## ASSESSMENT REPORT

### Mixed-Use Development, Ettalong Beach MP 09\_0121 MOD 3

This report is an assessment of a request to modify the Project Approval (MP 09\_0121) for a mixed-use development at Ettalong Beach in the Central Coast local government area.

**Figure 2** Approved and proposed north and south elevations (source: Proponent)

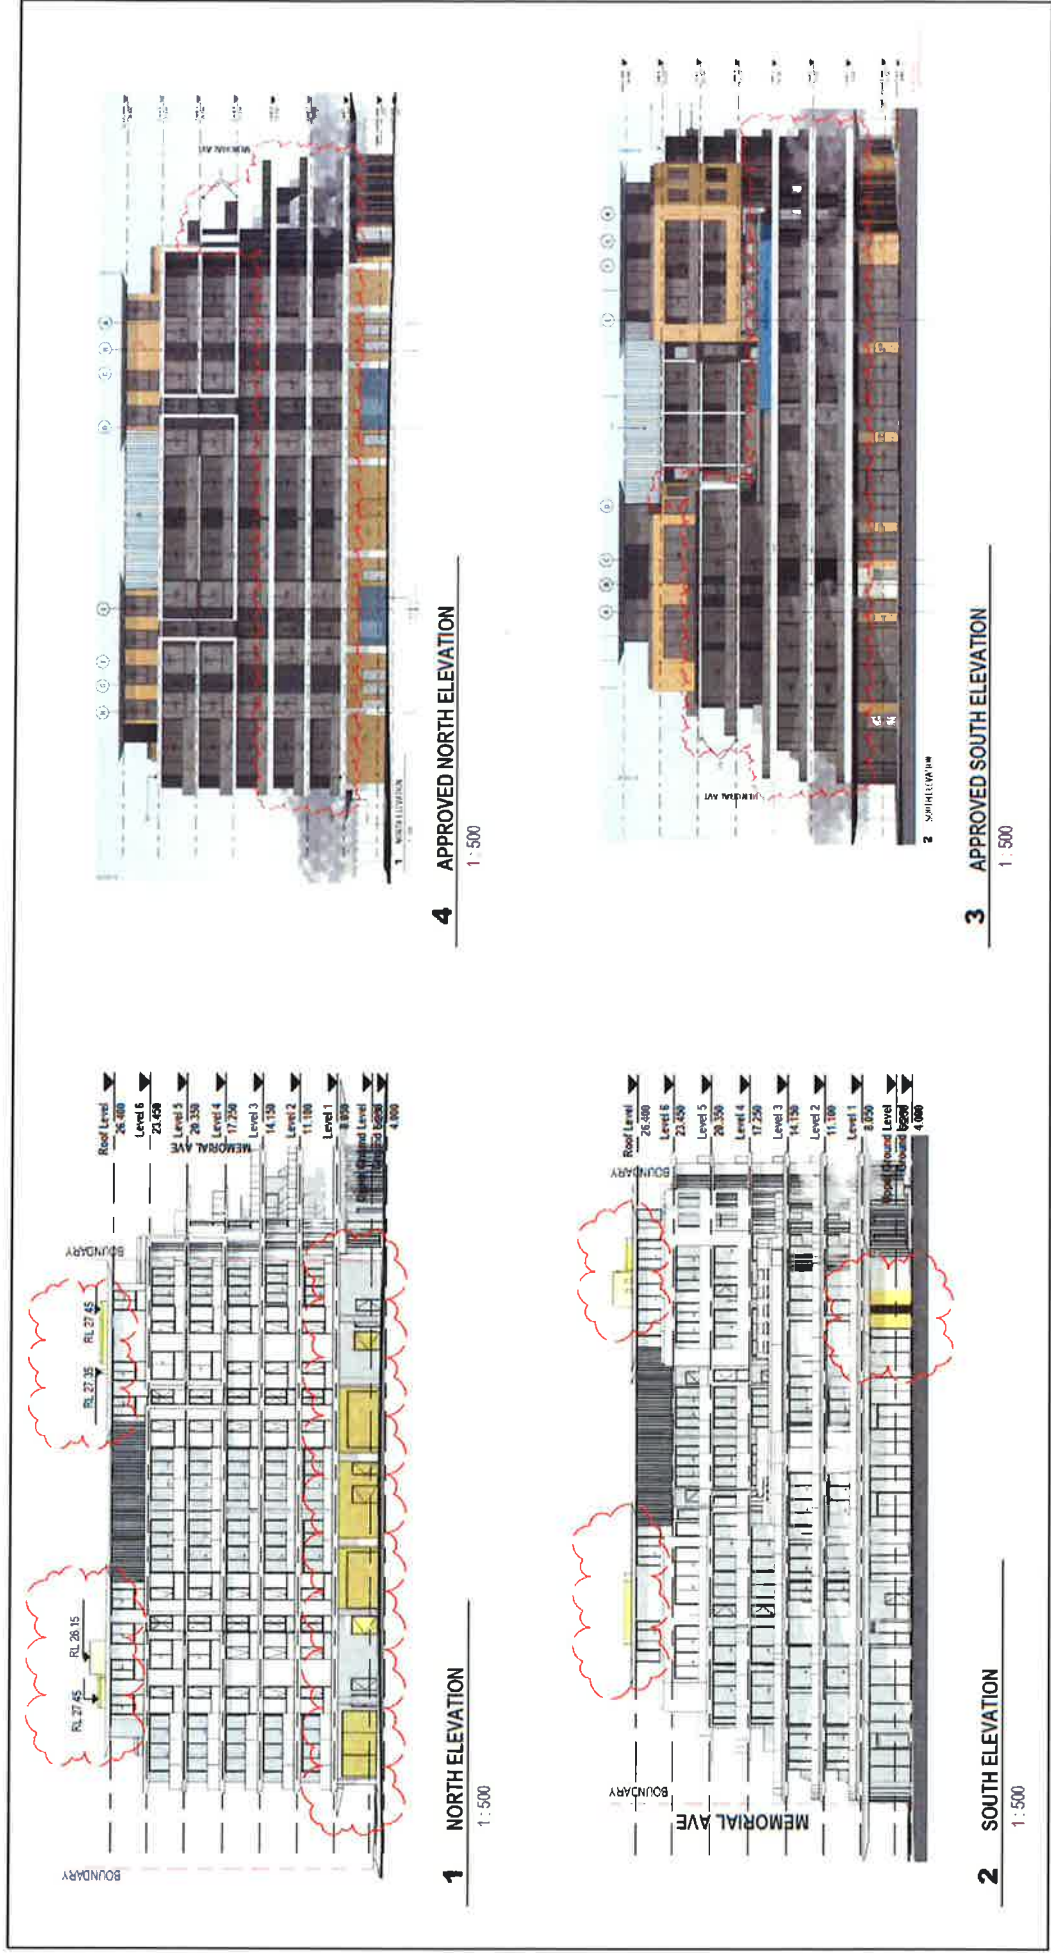
The proposal also seeks approval for minor modifications to the building façade, including additional glazing, new doorways and openings, the relocation of a roller door, and introduction of a fresh air intake vent. The Department notes the proposed changes are minor and the materials and overall design of the facades remains largely unchanged. The Department also notes the introduction of additional glazing would improve visual presentation to the street.

The Department therefore considers the proposed changes to the built form would not result in any unacceptable impacts.

Figure 5 Proposed lower ground floor plan (source: Proponent)

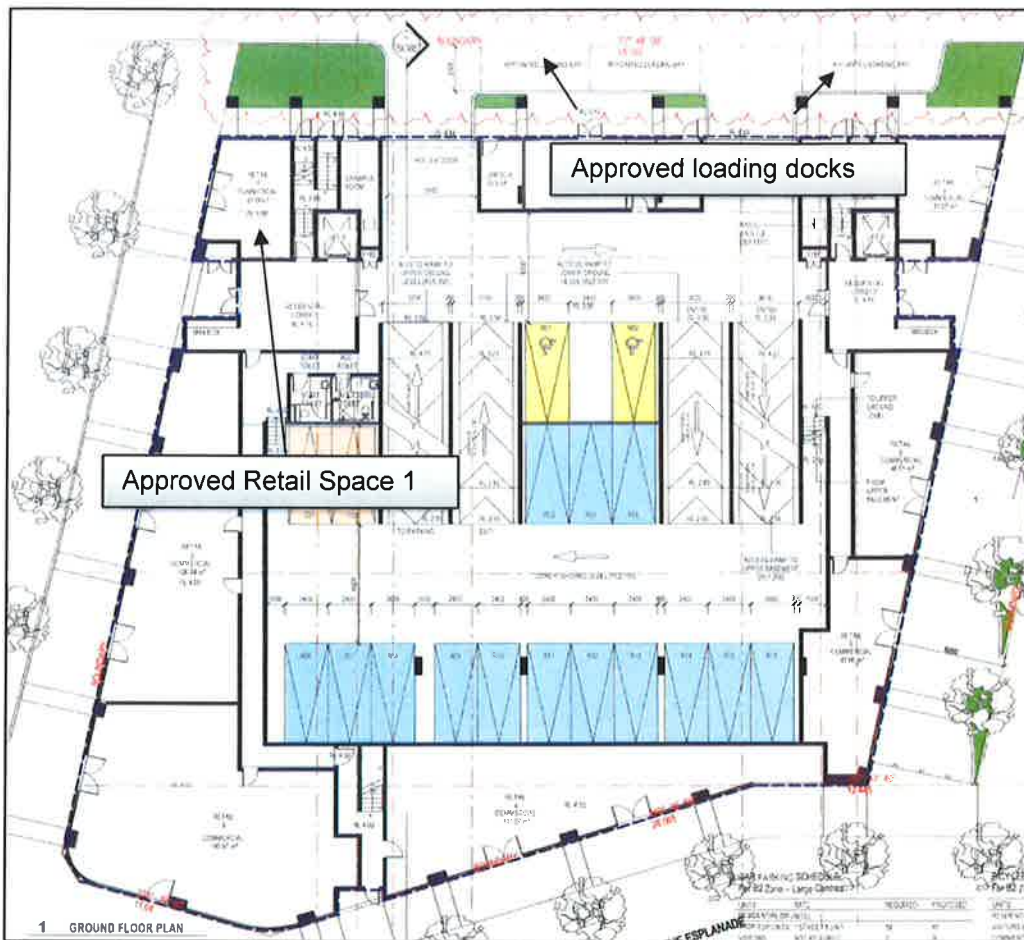
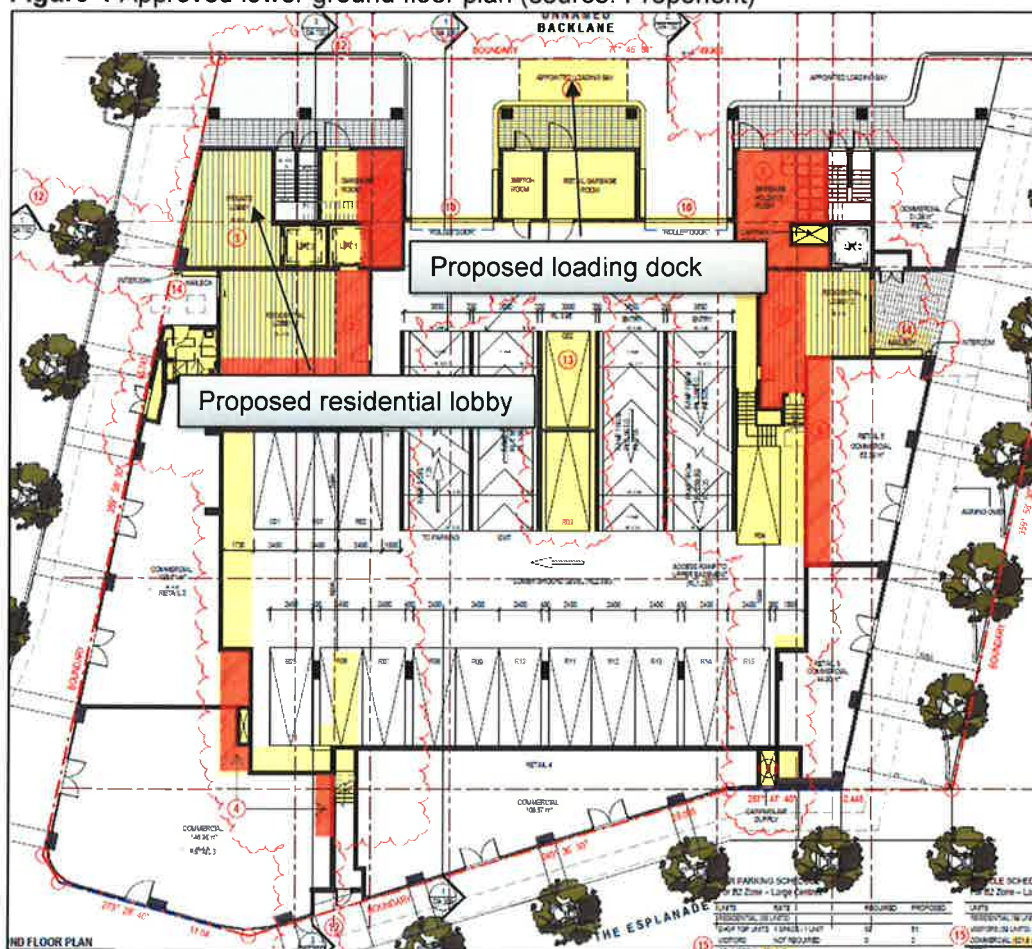
- Reduction in the number of loading bays from two to one
- Minor modifications to the ground level façade to incorporate increased glazing, new doorways and openings, relocation of an approved roller door, and introduction of a fresh air intake vent

<i><b>Issue</b></i>	<i><b>Consideration</b></i>	<i><b>Recommendation</b></i>
	from the footway.	
<i><b>Loading Facilities</b></i>	<ul style="list-style-type: none"> <li>The modification request seeks to reduce the number of loading bays from two to one.</li> <li>The Department considers one loading bay is adequate for the proposal as: <ul style="list-style-type: none"> <li>it would continue to meet the requirements for loading facilities under the Gosford Development Control Plan 2013 (DCP)</li> <li>a reduction in the number of retail tenancies (from seven to six) is proposed</li> <li>vehicles would still be able to enter and exit the site in a forward direction.</li> </ul> </li> <li>Council raised no objection to the proposal, but noted the reduction in loading bay areas along the laneway would require the layback to be reduced from 44m to 29m.</li> <li>The Department has therefore recommended Condition B7(h) be modified to require a 29m heavy duty vehicle crossing be provided along the southern boundary of the laneway.</li> <li>The Department therefore considers the proposed reduction in the number of loading bays is acceptable subject to the recommended modified condition.</li> </ul>	The Department has recommended Condition B7(h) be modified to require a 29m heavy duty vehicle crossing be provided along the southern boundary of the laneway.

**Figure 6** Internal path to retail garbage room (source: Proponent)

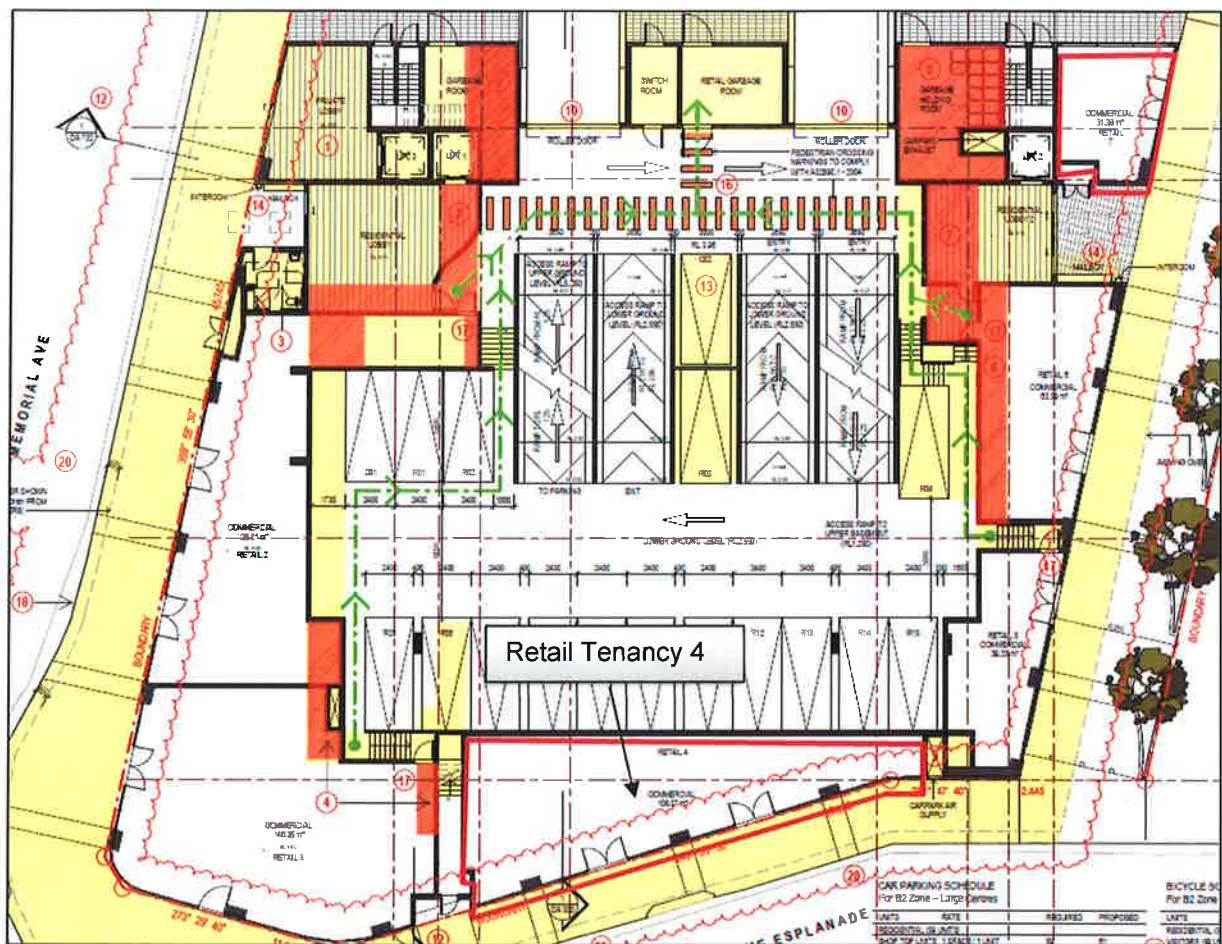
The proposal seeks to remove internal access corridors from the retail spaces to the waste storage room, and incorporate this space into the retail tenancies. Council requested that a revised Ground Floor Plan be submitted, indicating the path of travel from the internal access of each retail space to the waste storage enclosure.

Council reviewed the updated documents, and advised the Proponent's response addressed its concerns, however Retail Tenancy 4 should be provided with internal access to the waste storage room.

The Proponent submitted a revised Waste Management Plan and updated Architectural Plans addressing Council's requests (see **Figure 6**).

**Figure 7** Approved restricted access from Tenancy 4 (source: Proponent)

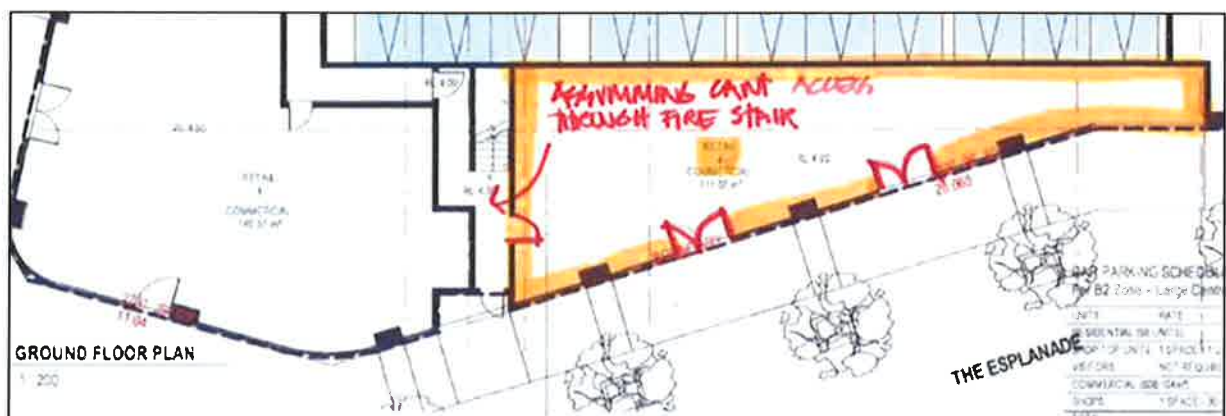
Council responded, noting the arrangement is not desirable and may impact the future use of the tenancy, but did not request further amendments to the plans.

In response, the Proponent confirmed under the approved plans (MOD 1), internal access from Retail Tenancy 4 to the waste room was restricted by locked doors to the fire stairs (see **Figure 7**).

The Department acknowledges Council's concerns regarding access to the waste room from the tenancies, but notes the arrangements have not altered from the approved development. The Department also notes subsequent approvals for uses within the tenancies will be required to address waste storage and ensure appropriate measures are implemented. The Department therefore considers the proposal is acceptable in terms of access to waste storage.

Figure 8 Lift overrun sightlines from Memorial Avenue (source: Proponent)

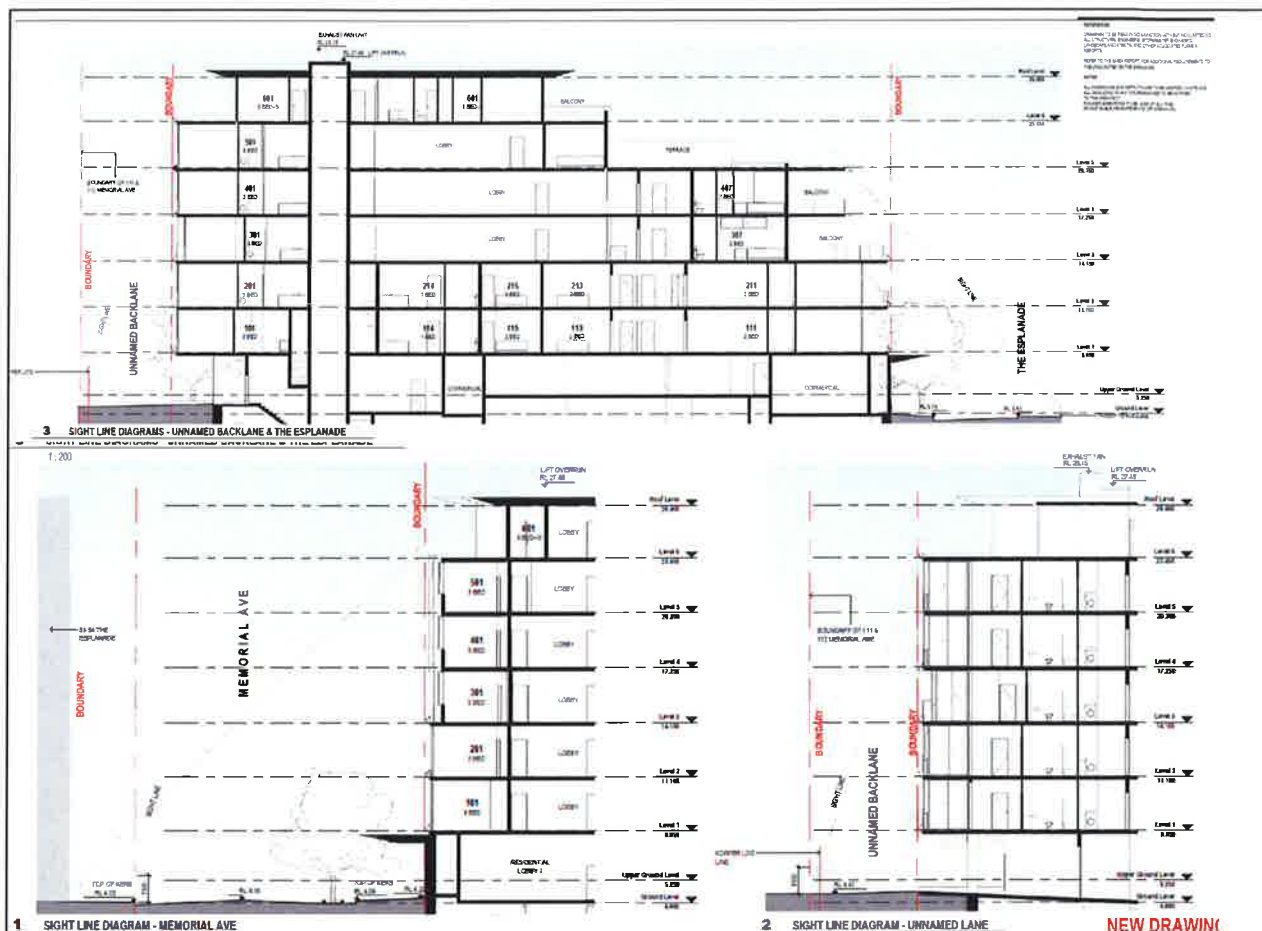
The proposal seeks approval for lift overruns associated with lifts 1 and 2, and the proposed lift 3. This would increase the height of the building within these areas by 0.6 m and result in a total height of 23.45 m. The Department notes the maximum permitted height for the site under the Gosford Local Environmental Plan 2014 (LEP) is 11.5 m.

While the additional height would continue to exceed the maximum building height of 11.5 m permitted under the LEP, the Department notes the proposed height is lower than the original approved height of 23.5 m (which was subsequently reduced to 22.85 m under MOD 1).

- the proposed increase in height is minor and relates only to the lift overruns
- the lift overruns are set back from the edge of the building, minimising visual impact from the street, as shown in **Figure 8**
- the additional shadows associated with the overruns are contained within the building footprint and would not have any impact on surrounding properties or public open space
- the proposed height is consistent with the original approval.

On this basis, the Department is satisfied the additional height associated with the lift overruns would not result in any unacceptable visual, amenity or overshadowing impacts beyond those already assessed and approved.
